**PLANNED UNIT DEVELOPMENT
& SUBDIVISION STAFF REPORT****Date: November 17, 2005****DEVELOPMENT NAME**

Pecan Cove Apartments, Ltd.

Truevine Missionary Baptist Church Subdivision

LOCATION1801 Holt Road
(North side of Dr. Martin Luther King Jr. Avenue,
extending Northeast to Holt Road, and extending
Northwest to Yukers Street)**CITY COUNCIL
DISTRICT**

SUBDIVISION PLAT

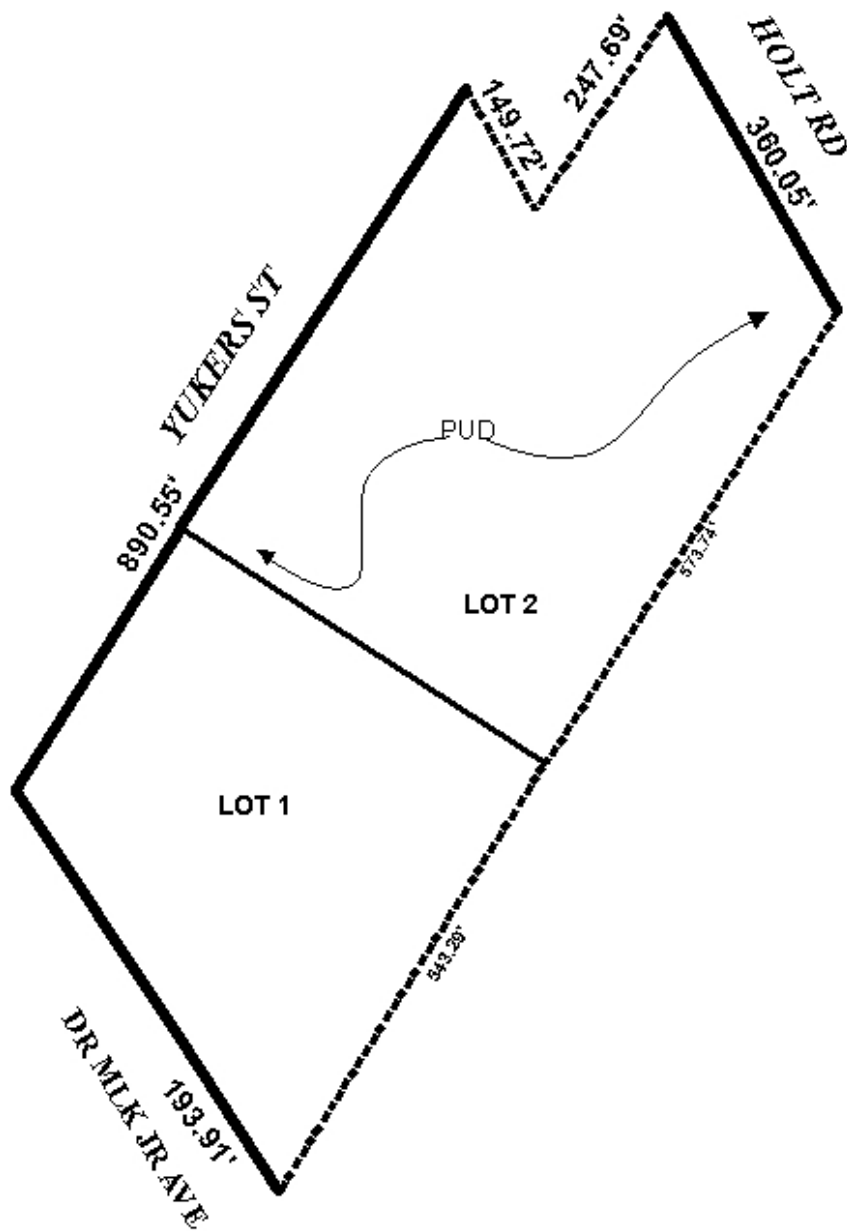
Regarding the proposed subdivision, the site meets most of the minimum requirements of the Subdivision Regulations. However, there is an outparcel that was separated from the parent parcel after the Subdivision Regulations went into effect; as it is also owned by the applicant, this parcel must be included in the subdivision application to bring it into compliance. This will necessitate revision of the legal description of the property, and submission of additional notification fees, and lot fees (if the parcel is included as a separate lot). If proposed Lot 1 is to be used as part of the church property, it should be combined with the outparcel as a single lot.

Subdivision Based on the preceding, this application is recommended for holdover until the December 15th meeting, to allow the applicant to submit a revised plat including the Southwestern outparcel, a revised legal description, and any additional notification and lot fees. These materials should be received by Urban Development by November 21st.

The applicant has submitted revised plats, additional fees, and additional notices, to include the Southwestern parcel in the subdivision application. This addition does not affect the PUD application. The additional parcel, which includes the church building, will be included in proposed Lot 1, while Lot 2 is proposed to be developed as the Pecan Cove Apartments. The addition brings the total area of the subdivision to approximately 11.1 acres. It should be noted that there is an error in the revised legal description, and that the phrase regarding a 134.86-foot measurement should be deleted. With the addition of the parcel, the plat still meets the minimum requirements of the Subdivision Regulations.

Subdivision Based on the preceding, this application is recommended for Tentative Approval, subject to the following conditions: 1) the dedication of sufficient right-of-way to provide 25 feet from the centerlines of Holt Road and Yukers Street; 2) the depiction of the 25-foot setbacks on the final plat, measured from the property line after dedication; and 3) the correction of the error in the legal description.

SITE PLAN

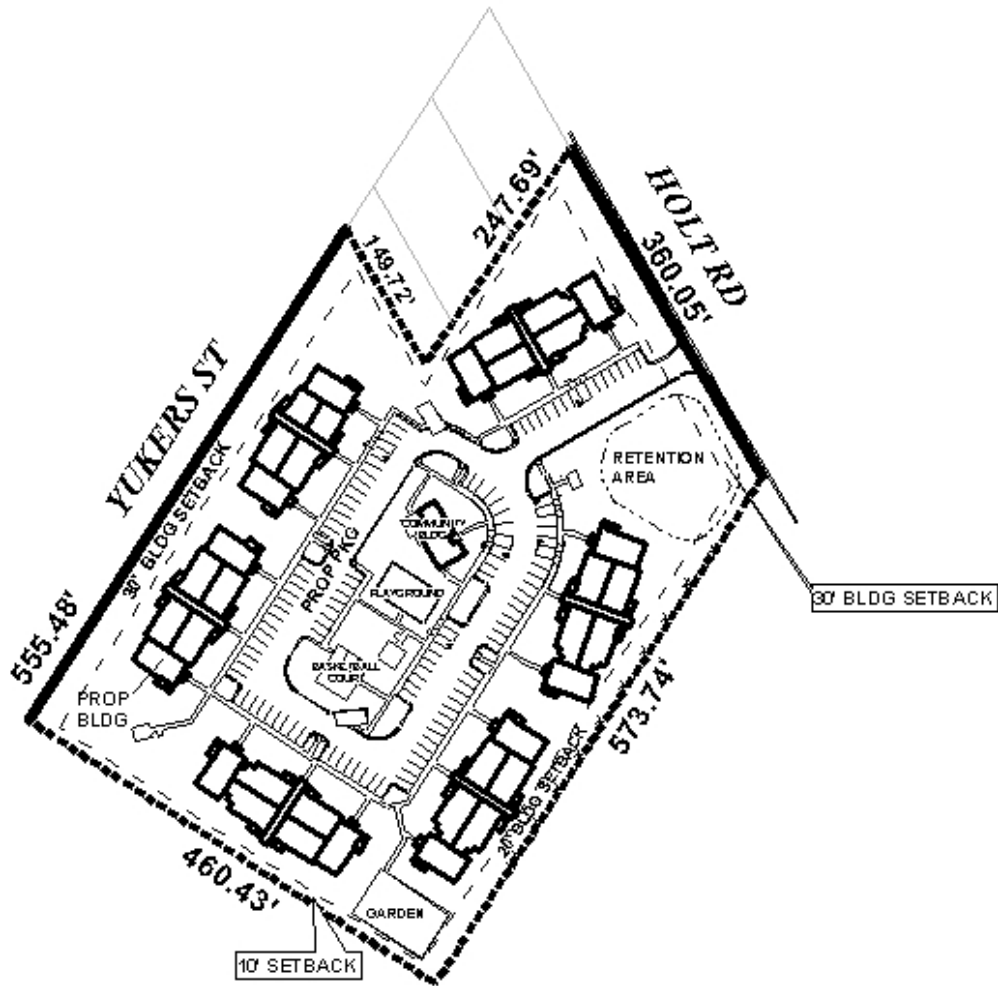
The site plan shows 120 parking spaces, which would exceed the requirements for the 60 units. Circulation and maneuvering meet the standards of the Zoning Ordinance. The site also exceeds the common open space requirements for a 60-unit complex. Building spacing appears to be adequate, with the shortest distance between buildings being 30 feet. If the buildings exceed 30 feet in height, building spacing must comply with Section V.C.2.b. of the Zoning Ordinance (*"A building shall be located no closer to another building than a distance equal to the height of the taller building of the two...[and] for a two-story building such distance shall be not less than 30 feet in the case of two walls having windows...."*).

Regarding the location and general compatibility of the site, a number of houses along Oak Drive Court, to the Southeast, back up to the site; and perhaps more significantly, nearly all the houses along Yukers Street face the site. The site is currently undeveloped, and the residents of these neighboring houses enjoy views of a large wooded lot. To preserve the natural quality of the site, and the views of the surrounding houses, a vegetative buffer, rather than simply a privacy fence, is recommended for the perimeter of the site; and, to the extent possible, preservation of existing older vegetation is preferable to total replacement with new plantings.

Planned Unit Development Based on the preceding, this application is recommended for Approval, subject to the following conditions: 1) the dedication of sufficient right-of-way to provide 25 feet from the centerlines of Holt Road and Yukers Street; 2) the completion of the subdivision process prior to the issuance of any permits; 3) compliance with Section V.C.2.b. of the Zoning Ordinance (“A building shall be located no closer to another building than a distance equal to the height of the taller building of the two...[and] for a two-story building such distance shall be not less than 30 feet in the case of two walls having windows....”); 4) the retention, to the extent possible, of the mature trees facing and adjoining R-1 properties, to be coordinated with Urban Forestry; 5) the provision and maintenance of a vegetative buffer where the site faces and adjoins R-1 properties, in compliance with Section IV.D.1.b of the Zoning Ordinance; and 6) full compliance with all municipal codes and ordinances.
